In the Matter of)
)
NORTHERN STATES POWER COMPANY) Docket No. 50-263
)
(Monticello Nuclear Generating)
Plant))

ORDER FOR MODIFICATION OF LICENSE

MONTICELLO OPERATION RESTRICTIONS

FIGURE A-1 MAXIMUM AVERAGE PLANAR LINEAR
HEAT GENERATION RATE VERSUS
PLANAR AVERAGE EXPOSURE

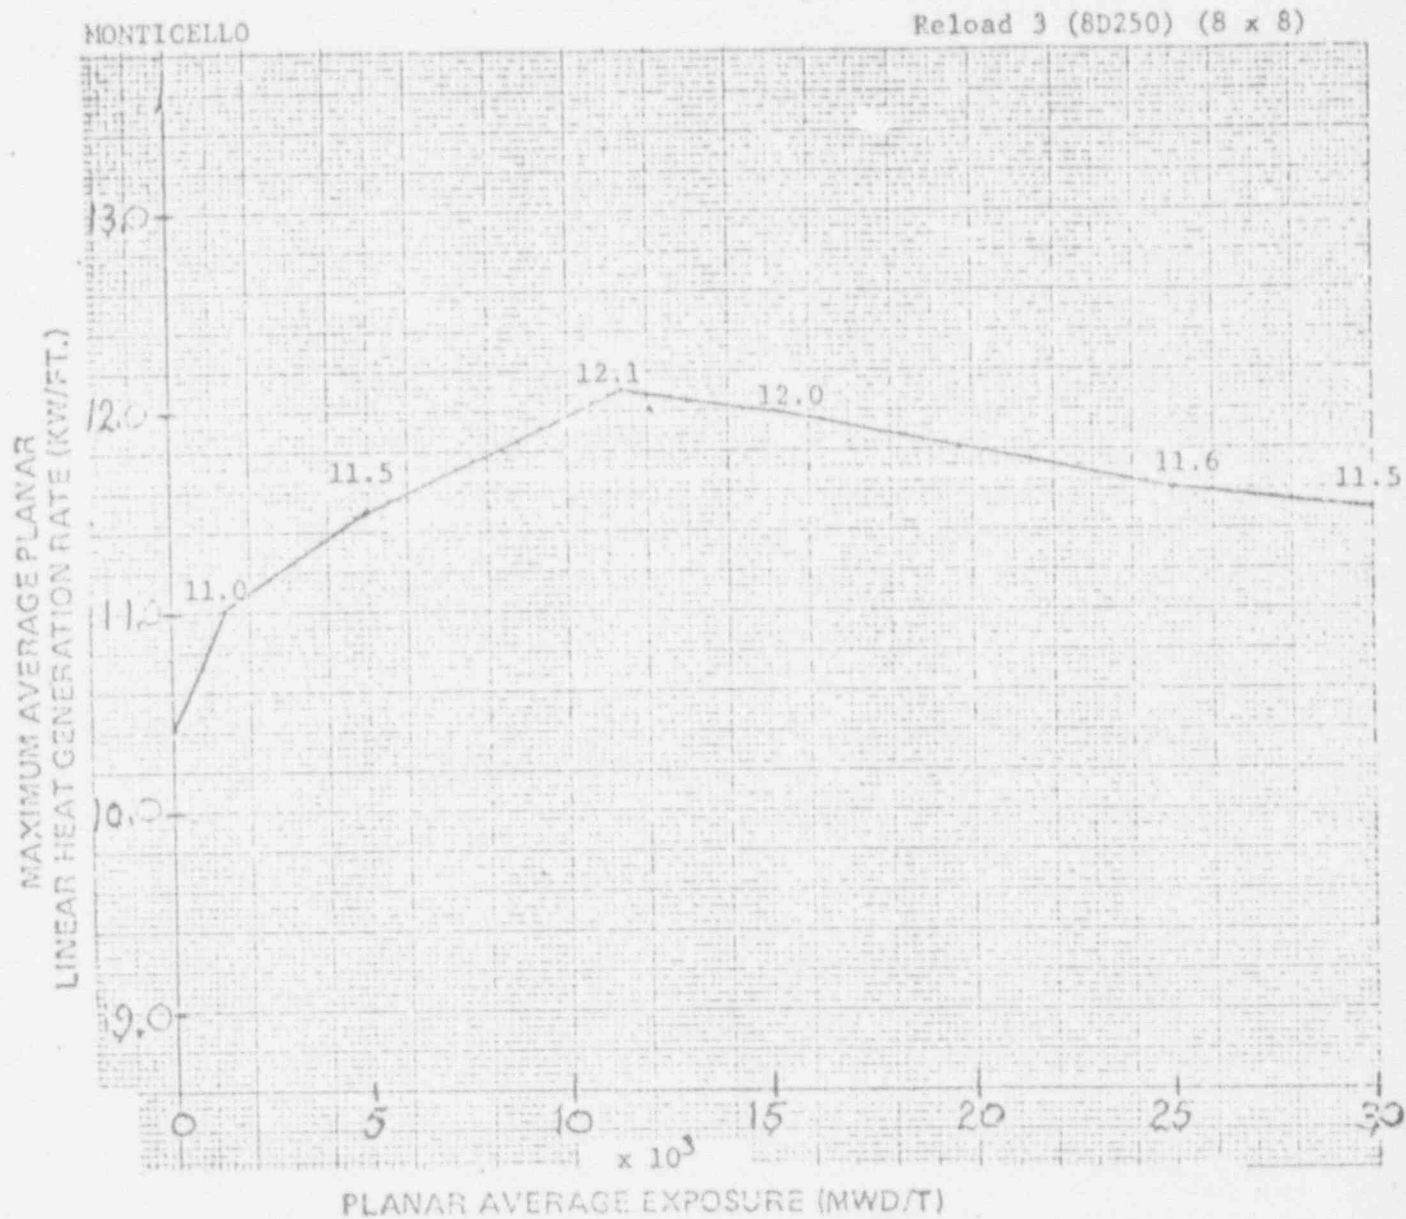
The proposed Technical Specification limiting conditions of operation present two limitations on power distribution related to the LOCA analysis. These are the limiting assembly maximum average planar linear heat generation rate, MAPLHGR, and the minimum critical power ratio limit related to boiling crisis, MCPR. The MCPR value used in the LOCA analysis was 1.19. The limiting value of MAPLHGR included with the proposed Technical Specifications submitted on August 5, 1974, have been revised to account for the General Electric ECCS Evaluation Model deficiencies which have been discussed in this report. The revised values are given in Figures B.3.11-1A and B.3.11-1B. Operation shall conform to these values. Operation shall also conform to a MCPR value of 1.20 as proposed by the licensee.
